Service Bulletin

SUBJECT: Mandatory replacement of magnetos on certain 6-cylinder Teledyne Continental Motors engines, including like versions built under license by Rolls-Royce.

SLICK Service Bulletin SB1-00C

FIGURE 1

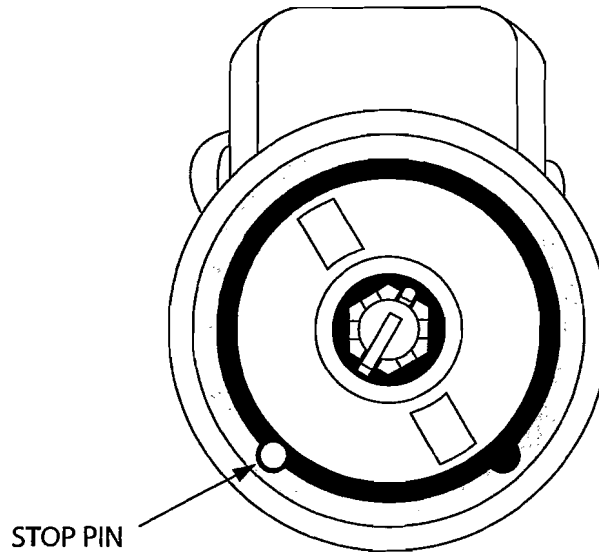
- A. Locate magneto serial number on magneto dataplate. If magneto serial number is determined to be within the range specified in this bulletin, remove the magneto from engine in accordance with the latest revision of the engine manufacturer's manuals.
- B. Inspect the magneto to confirm that the stop pin is present in the magneto frame. View the drive end of the magneto where the impulse coupling is attached and position the magneto as detailed in Figure 1. The magneto stop pin should be located at approximately the 8 o'clock position. Only one stop pin is installed in the magneto and the hole in the magneto frame located at the 4 o'clock position should be open.

- C. If the stop pin is present in the magneto frame, replace the magneto with a new or serviceable unit. If the magneto stop pin is not present in the magneto frame, proceed as detailed in step D or E.
- D. C-125, C-145, O-300, IO-360, and TSIO-360 engines:
